1.0 SUMMARY OF NON-MATERIAL AMENDMENTS (ELEVATIONS)

KEY ELEVATION
Drawing: 19555-CPA North Elevation

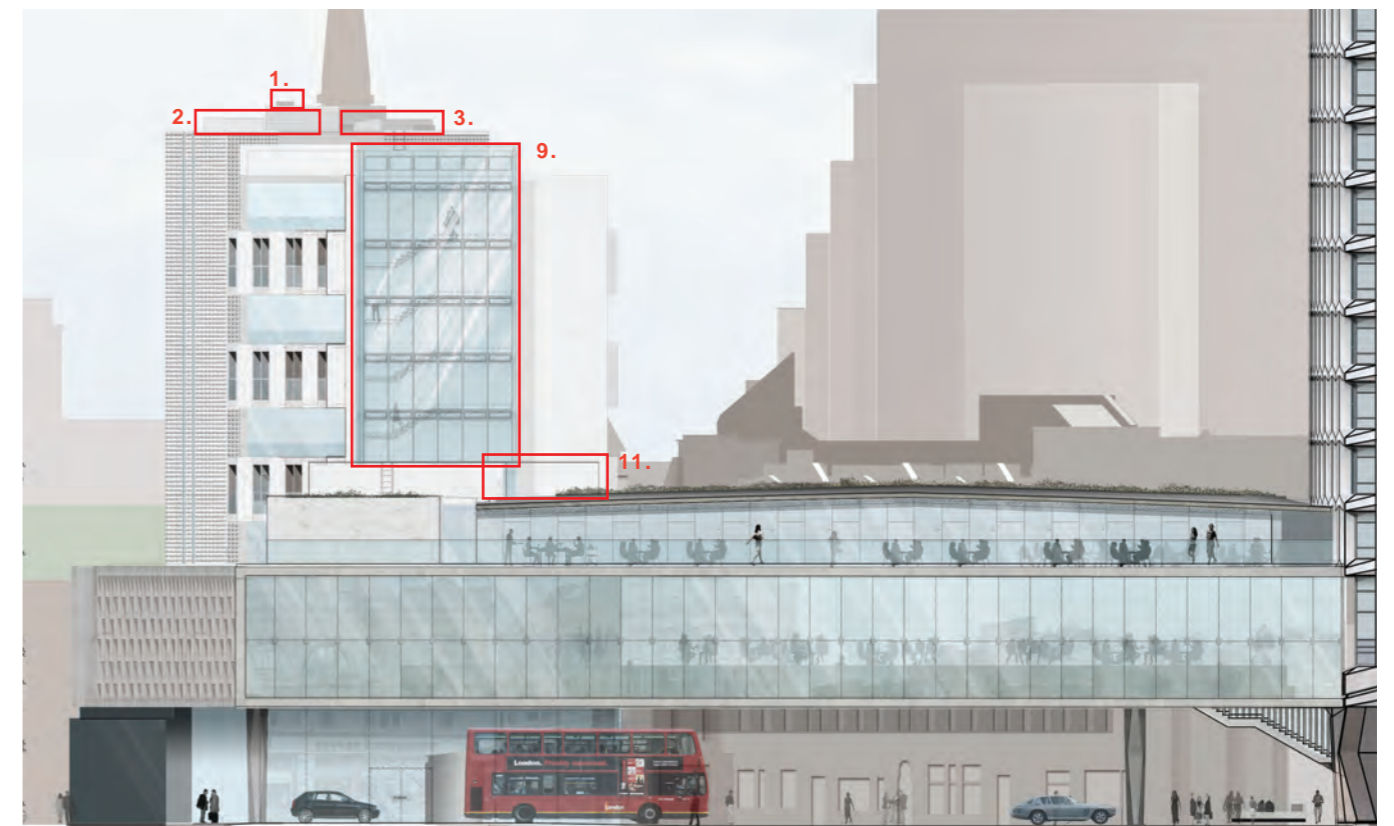
Amendment 1: Flue heights increased

Amendment 2: Additional fresh air intake equipment to CPW level 09 roof

Amendment 3: Additional smoke vent equipment to CPW level 09 roof

Amendment 4: Extension of CPW level 09 roof parapet over CPH main roof

Amendment 5: Timber handrail to CPW West facade reduced

Amendment 6: Precast cladding edge extended

Amendment 7: Glazing reconfigured to CPW South-West & West elevations

Amendment 8: Extended plinth and metal PPC lining to UKPN substation in lieu of louvre overcladding

Amendment 9: CPH North & South stairwell cladding and rooftop balustrades reconfigured

Amendment 10: Lifts 07 & 08 realigned and cladding reconfigured

Amendment 11: Lift 06 extended to serve level 02

Amendment 12: PPC metal panels to plant rooms in lieu of proposed glazing

Amendment 14: Louvres extended to underside of level 00M slab

Amendment 15: Glazing to staff exit extended to underside of CPL soffit

Amendment 16: Glazed gate heights aligned with adjacent doors & glazed overpanel added

KEY ELEVATION
Drawing: 19556-CPA East Elevation

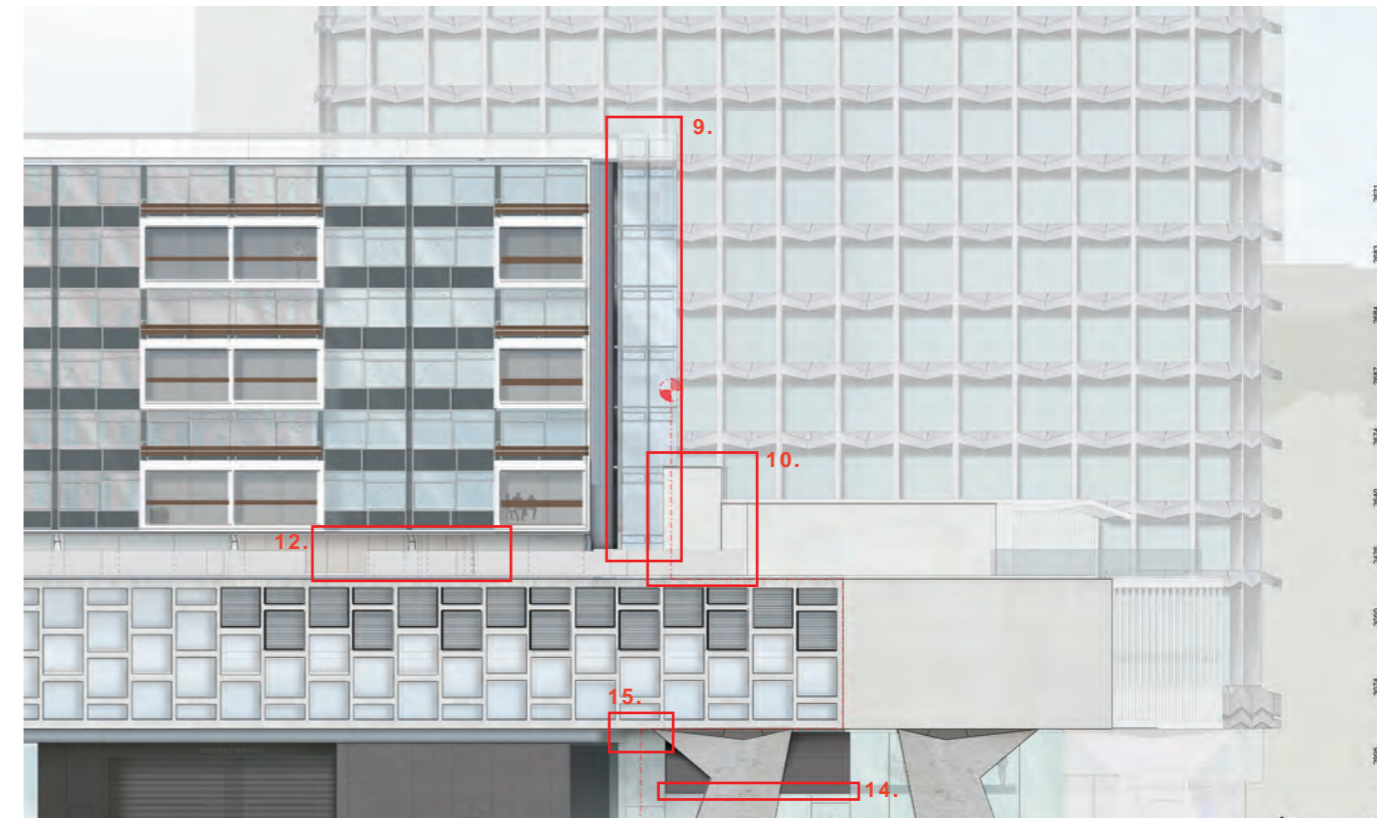
Amendment 13: East elevation revised to show correct retail duct route
